Washington State Convention Center Addition Project

Design Review Board Design Recommendation Meeting 01
05-03-2016

PROPERTY ADDRESS	SITE A 1600 9th Avenue
SDCI PROJECT #	3020176

2 EDG 03 COMMENT
SUMMARY

9TH AVE PLAN OF MIXING ZONE

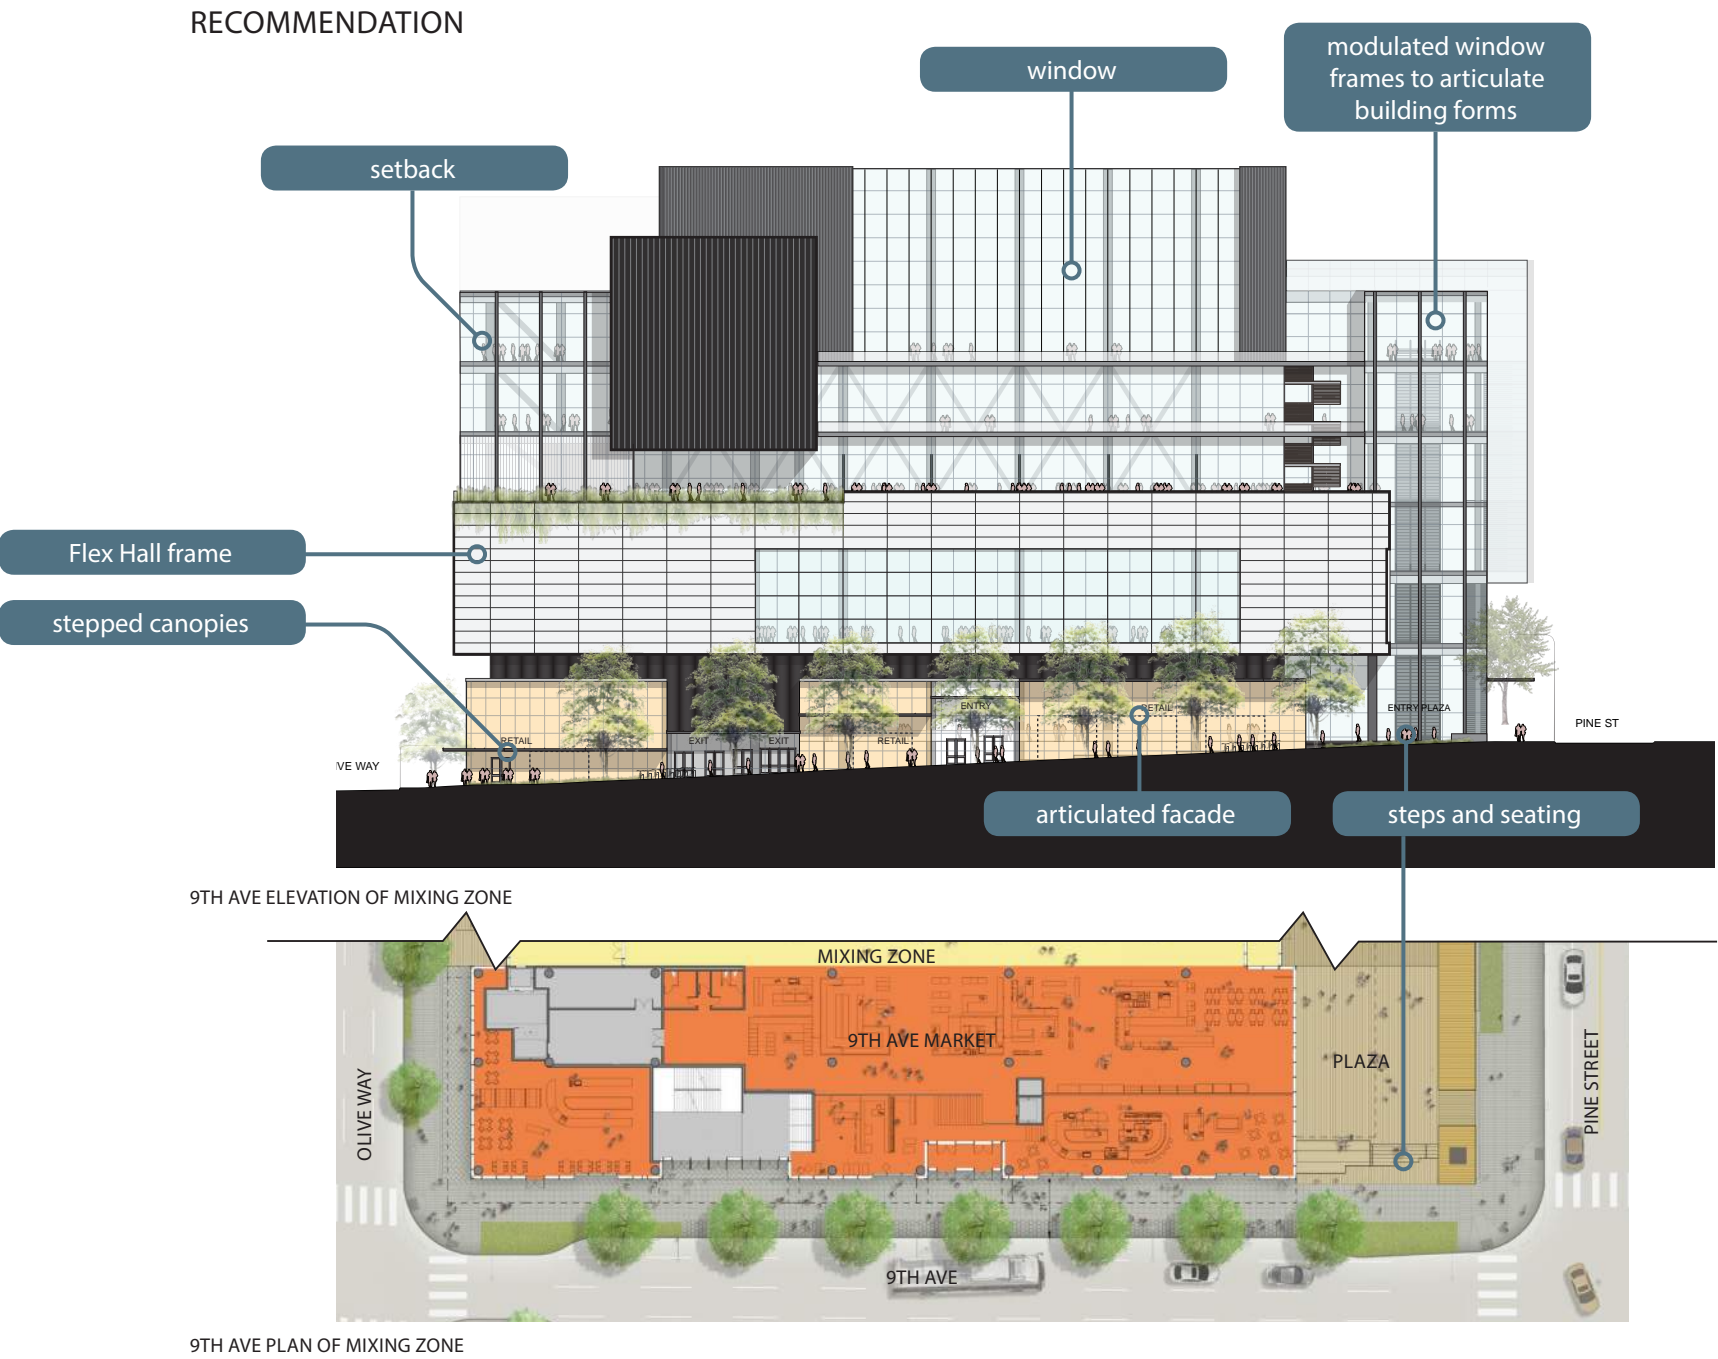
At the EDG#3, the Board agreed the stairs leading up to the plaza from 9th were too narrow, and the wide, long berm actually creates a barrier (see pg 43/left). The Board recommended widening the stairs, similar to those along Pine, incorporating smaller planters to maintain some Green Street character, and easing back the planter and bench at the corner to accommodate diagonal pedestrian desire lines from the busy crosswalks to the primary CCX entrance doors. The Board supported the new gradual, mid-block stairs on 9th up to the mixing zone, and encouraged them to be less abrupt at the sidewalk transition; the adjacent public elevator would be less obstructive if a glass enclosure.

RESPONSE - The plaza design has been developed to provide a more generous entry along 9th Avenue, using planted areas and seating opportunities to mitigate the difference in grade from Pine Street to 9th Avenue. The market is now entered directly from the sidewalk, with the stairs and elevator internal to the market circulation, providing better connection and pedestrian circulation between the difference in grade.

OLIVE WAY ELEVATION

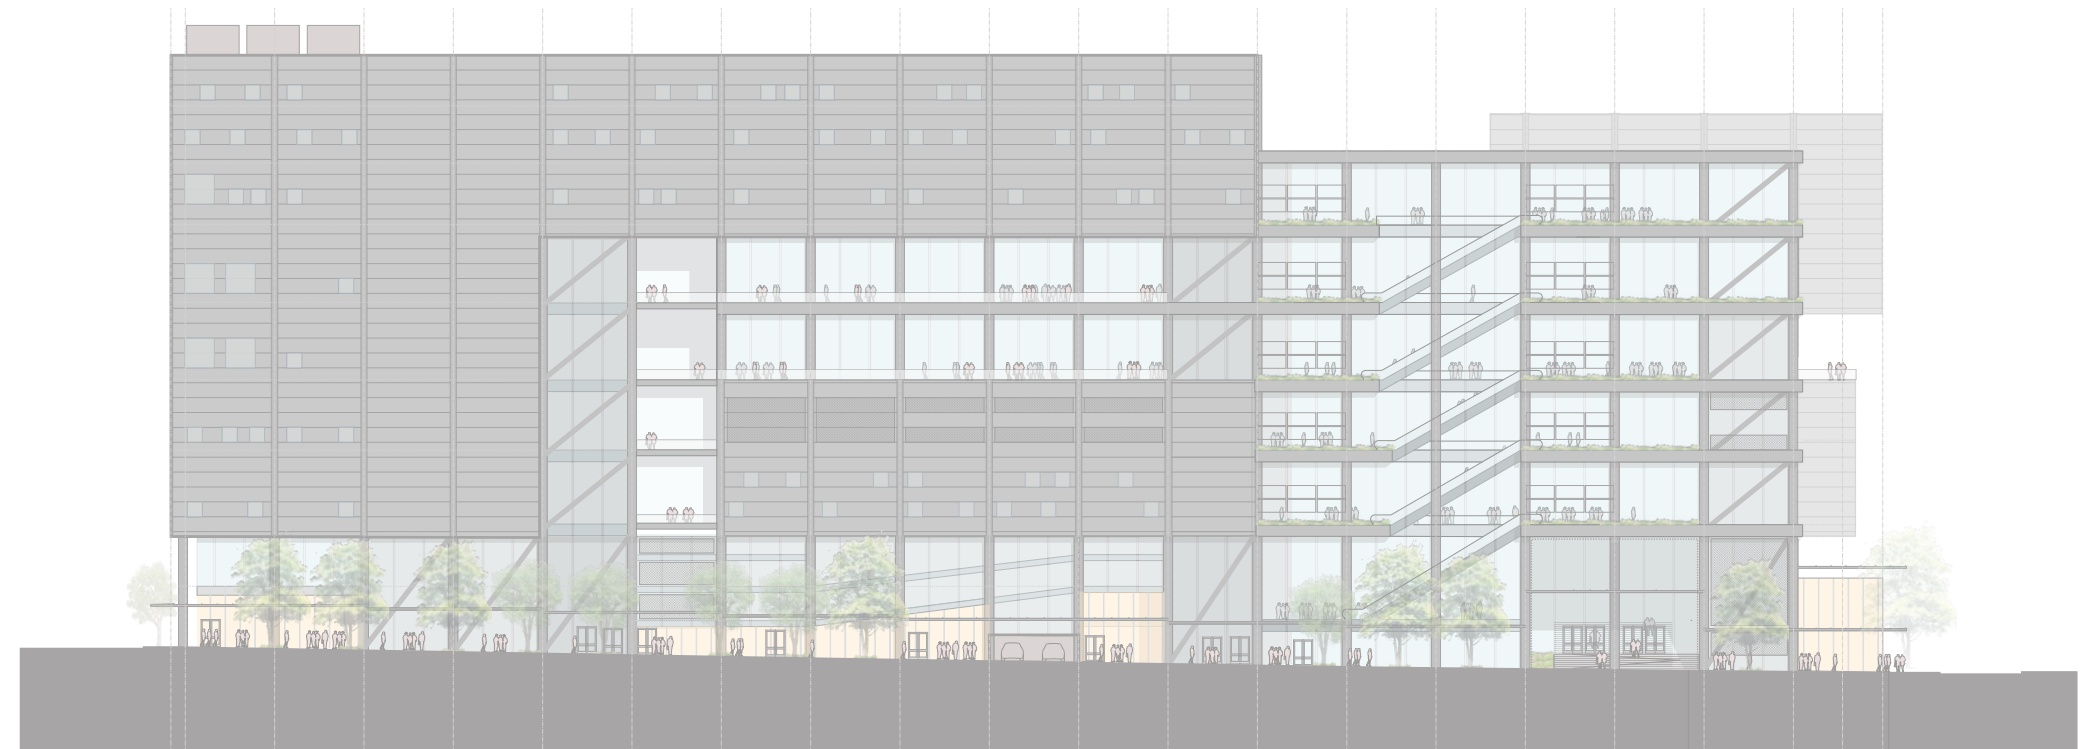
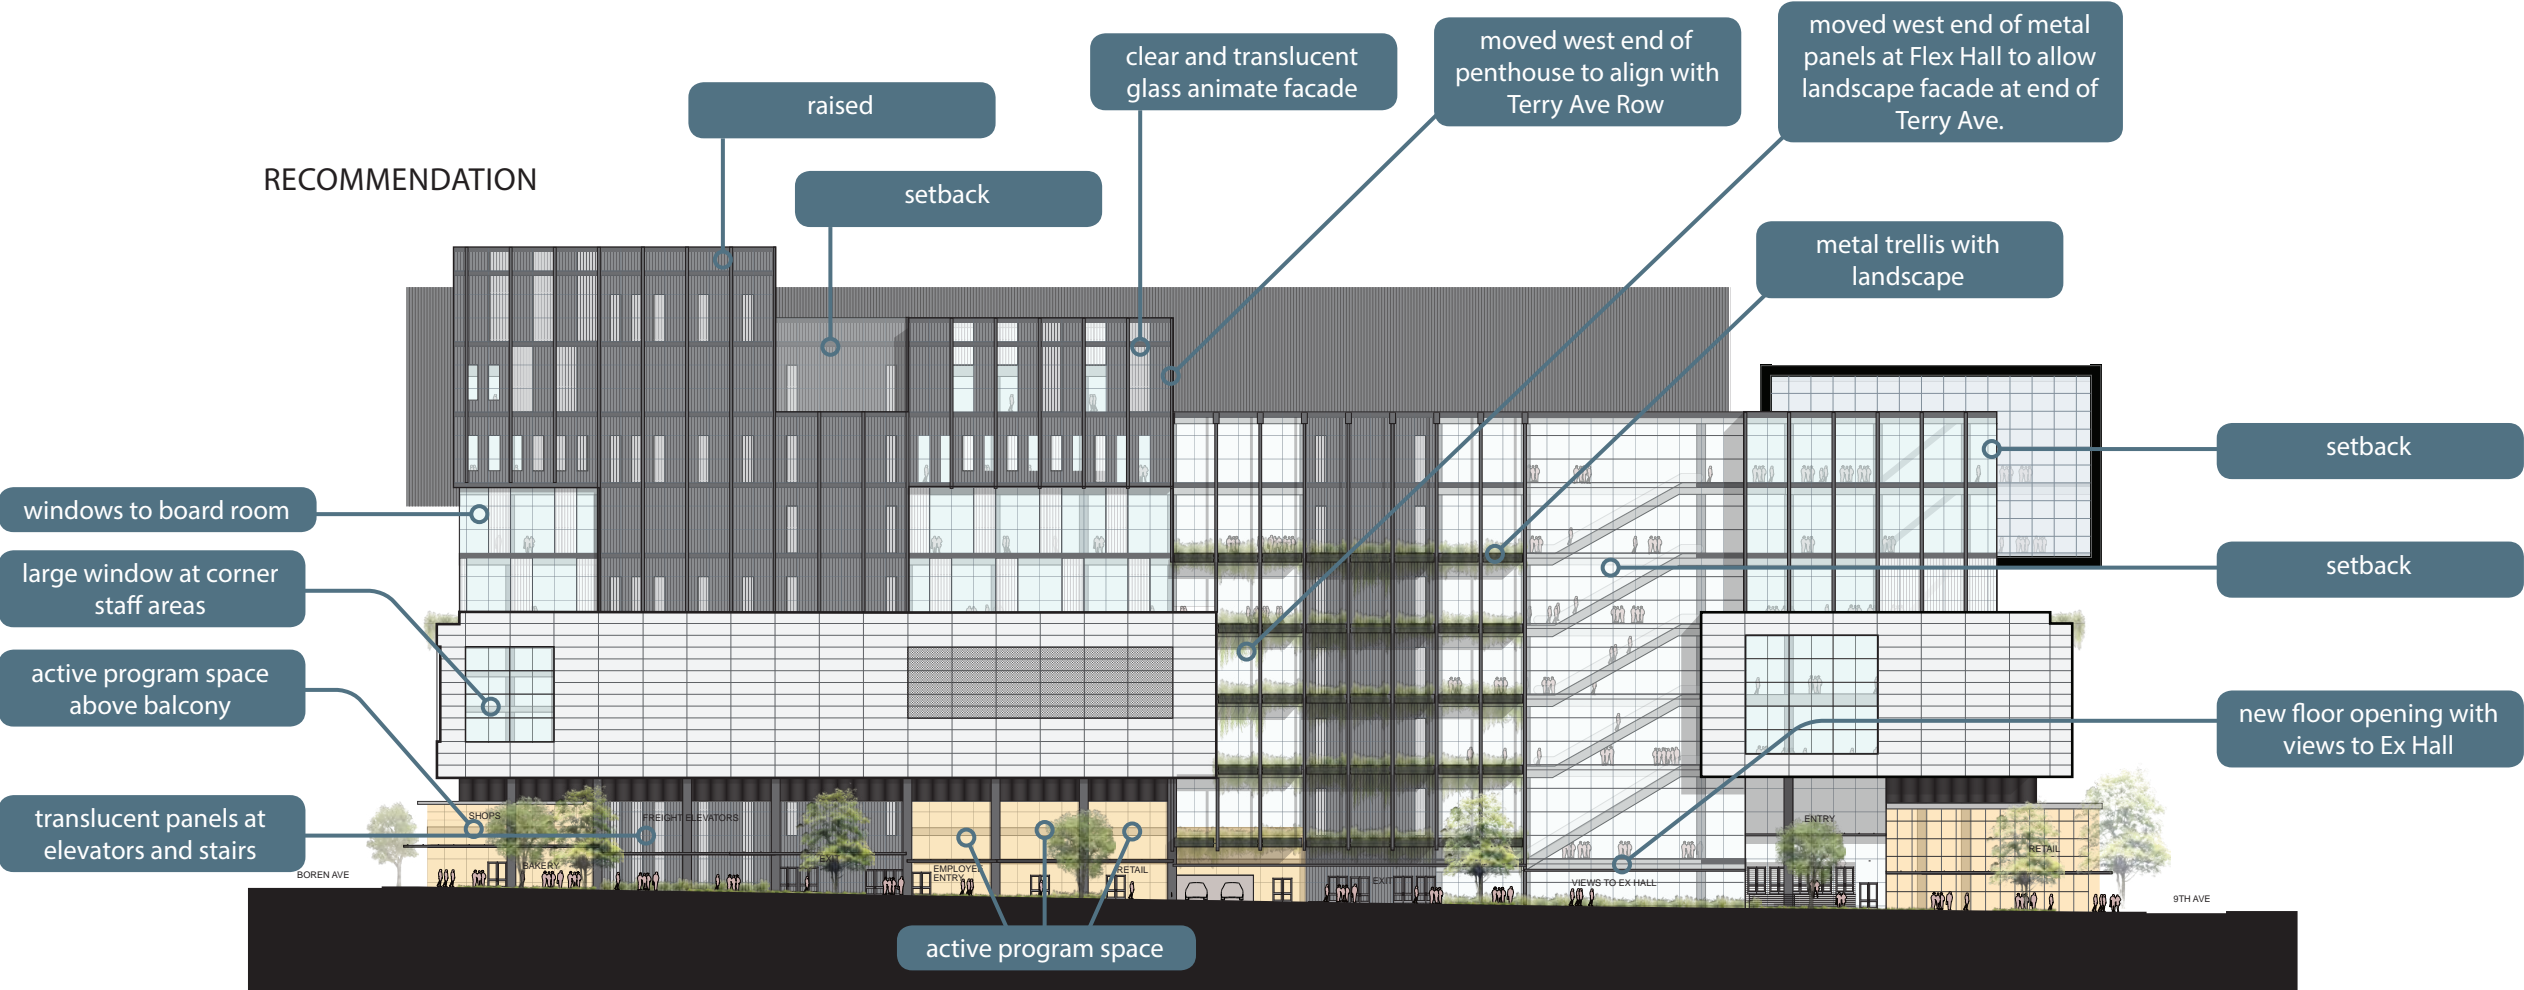
At the EDG#3, the Board appreciated the multiple perspective views provided, but recommended additional views along Terry Avenue looking toward the Olive facade that is the Terry Green Street terminus, developing an intentional and scaled elevation response to that terminus condition, and showing the pedestrian edges of Terry Avenue and the adjacent building ground floors in detail. Fully conveying all three facades holistically may require 2-3 perspectives.

RESPONSE - The Olive Way elevation has been revised to create a more expressively scaled facade with the surrounding context. The intersection of Terry Avenue at the mid-block is highlighted though a vertical setback in the building mass and an overlay of a finer scaled garden structure. This provides depth, texture, and richness appropriate to receive the Green Street character, transitioning west to link back to 9th Avenue. The co-development towers that define Terry Avenue on the east and west will be presented at a subsequent meeting.

RESPONSE - The Olive Way elevation at the end of Terry Avenue is composed of several textural layers that provide shifting depth, texture, and variety marking a vertical zone at the end of the Green Street. The garage portal has shifted slightly off axis to the east, while maintaining its connection to the signaled intersection.

OLIVE WAY ELEVATION

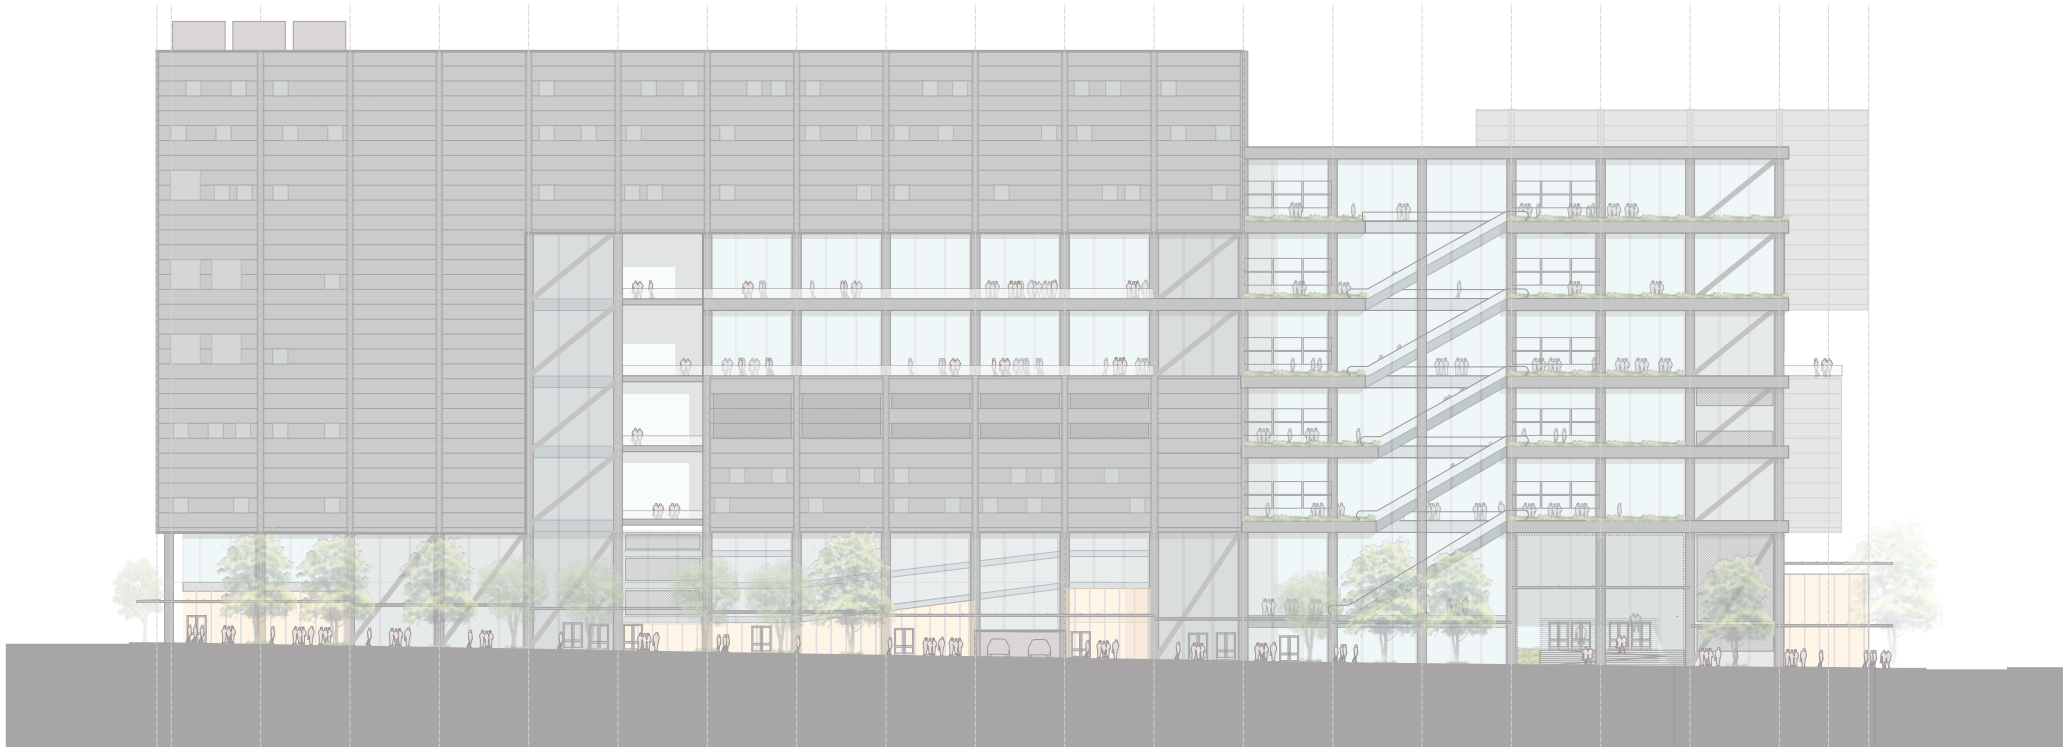
At the EDG#3, the Board strongly supported the added mid-block retail along Olive Way, and the highly transparent treatment of the nearby employee entrance and parking lobby (see pg 44). The Board did not support exposing the parking floors to the Olive facade, but was enthusiastic about translucent glass at the exit stair towers, and especially at the northwest and larger northeast elevators, showing the movement behind. The Board agreed the Olive stair/ramp into the 'mixing zone' is a crucial activator, and widening/deflecting the east edge of the opening toward the Terry axis should be studied (see diagram pg 48, lower left).

Olive Avenue CCX Elevation Revisions: Conceal parking ramps and develop translucent glass portions at elevators. Consistent with the Departure #1 comments, revise the parapet and wall modulation of the large, flat eastern half of the Olive elevation. Study widening the stair/ramp at the north end of the 'mixing zone'.

RESPONSE - The parking ramps have been revised so they are no longer perceived on the building exterior. The retail and lobby activation is enhanced by the addition of large vertical openings at the building face adjacent to the entry that provide views deep into the activity of the facility on multiple levels. Additional planting areas along the building frontage at grade create variety at street level and anchor the garden concept at pedestrian level. The entry along Olive Way is better activated with retail fronting the corner on both sides, the service elevators relocated away from the facade.

RESPONSE - The parking ramps have been revised so they are no longer perceived on the building exterior. The west freight elevators have been relocated away from the facade. The east half of the Olive Way elevation has been recomposed to provide clarity of building elements and introduce more texture and variation with solid and translucent panels following the service elevators and egress stairs vertically down to grade. The Olive Way entrance has expanded visual connection from Terry Avenue with a large vertical opening at the building face strengthening views into and through the building.
